# Western Sub Regional RTEP: AEP Supplemental Projects

December 13, 2024

## AEP Transmission Zone: Supplemental S3441.1 and .4 Scope Change

# AEP Transmission Zone: Supplemental S3441.1 and .4 Scope Change

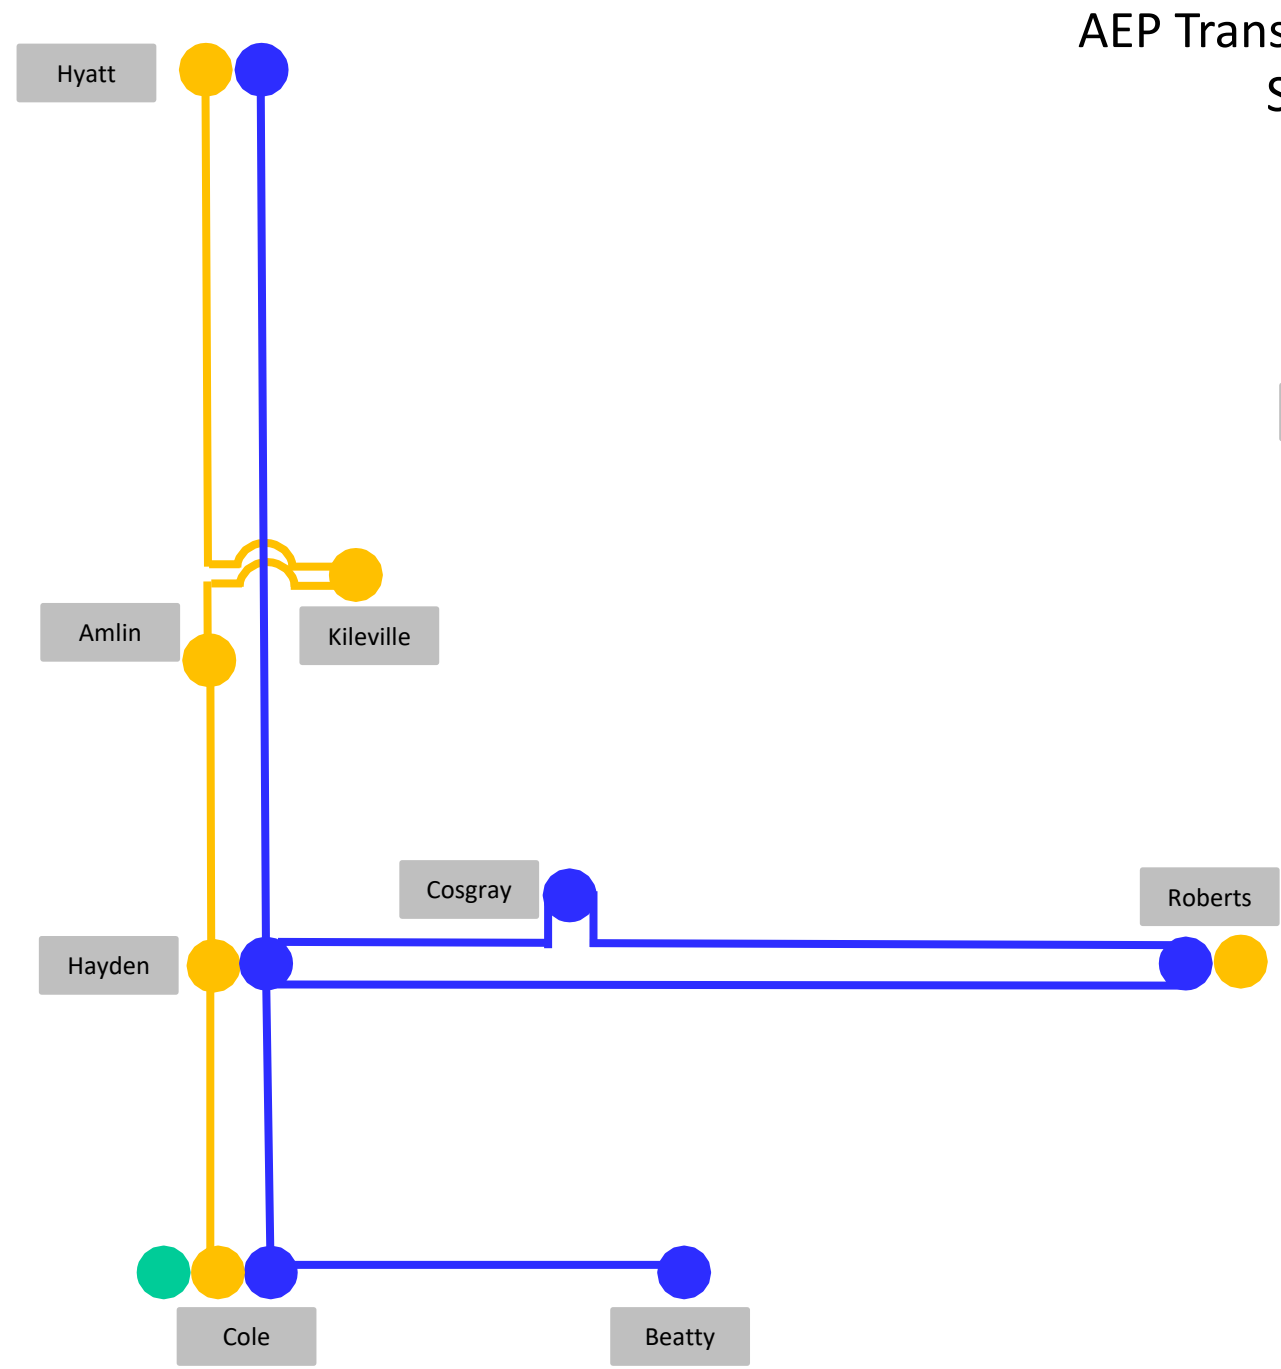
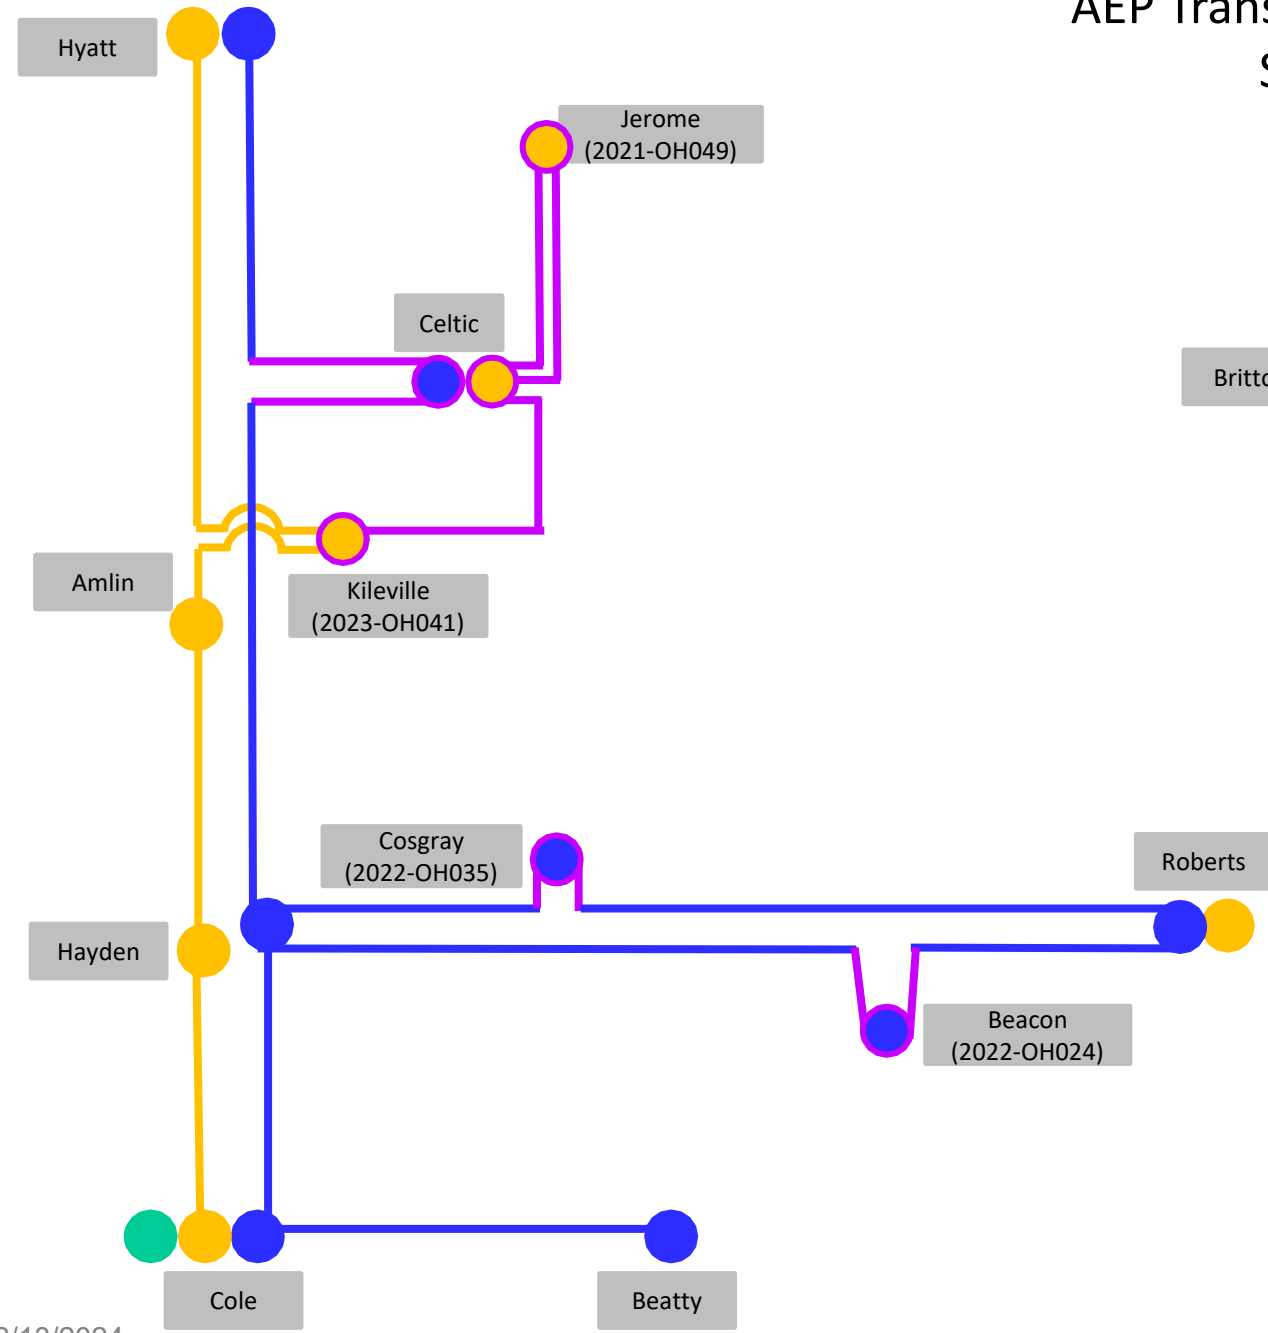
- After beginning project outreach and ROW activities it became apparent that given the amount of development in the area that building the initially proposed ~1.6 mile 138 kV line between Jerome and the existing Hyatt – Amlin circuit on a route NE of Kileville station was going to be extremely challenging from a property acquisition standpoint and would have a significant impact on initial conceptual cost estimates. Therefore, in working with the customer in the area, the decision was made to instead pivot to an alternative line route that involved ultimately serving the Jerome site out of a double circuit 138 kV line connected into Celtic station.

- Jerome 138 kV:** Construct a greenfield Jerome station with (~~10 11~~) 138kV 63kA 4000A circuit breakers in breaker and half bus configuration. Construct ~ 2.5 miles of double circuit 138kV transmission line extending from ~~Celtic &~~ Kileville station **to Jerome** utilizing 2-bundled ACSS Cardinal 954 (45/7) conductor, SE rating 1061 MVA. ~~Construct ~1.6 miles of double circuit 138kV transmission line extending from Jerome to cut in back to Hyatt – Amlin line utilizing 2-bundled ACSS Cardinal 954 (45/7) conductor, SE rating 1061 MVA.~~ Construct (4) 138 kV tie lines to the customers dead end structures ~0.05 miles utilizing ACSR Dove 556.5 (26/7) conductor SE 284 MVA. Customers will be directly connected at this station. Cost: **\$29.78 30 M (s3441.1)**

- Celtic 345/138 kV:** Originally, Kileville is the station that was envisioned (s2855) to serve 461 MW of demand with room for 345 kV expansion based on LOAs with the customer. However, land in the area of the proposed Kileville station was not available for expansion to install 345/138 kV transformation. Therefore, a new station site called Celtic is being proposed to serve as the 345 kV source for the 461 MW of load to be served in this area. Cut into the Hayden – Hyatt 345 kV circuit, reroute ~0.8 miles of the circuit and extend ~1.1 miles of new double circuit line, utilizing 2-bundled ACSR Pheasant 1272 (54/19) conductor, SE rating 2413 MVA, to the greenfield Celtic 345/138 kV station with (4) 345 kV, 63 kA, 5000 A breakers laid out as ring bus configuration on high side. Install two 675MVA-345/138 kV power transformers. Install (~~8 6~~) 138kV, 63 kA, 4000 A breakers & (2) 69.1 MVAR 138 kV Cap bank on low side configured as **breaker-and-a-half ring** bus with provisions for future expansion ~~breaker-and-half configuration~~. The proposed Kileville – Jerome 138 kV line will be brought in and out of the station **creating two 138 kV Celtic – Jerome circuits and a single Celtic – Kileville 138 kV circuit.** Cost: **\$70.31 60 M (s3441.4)**
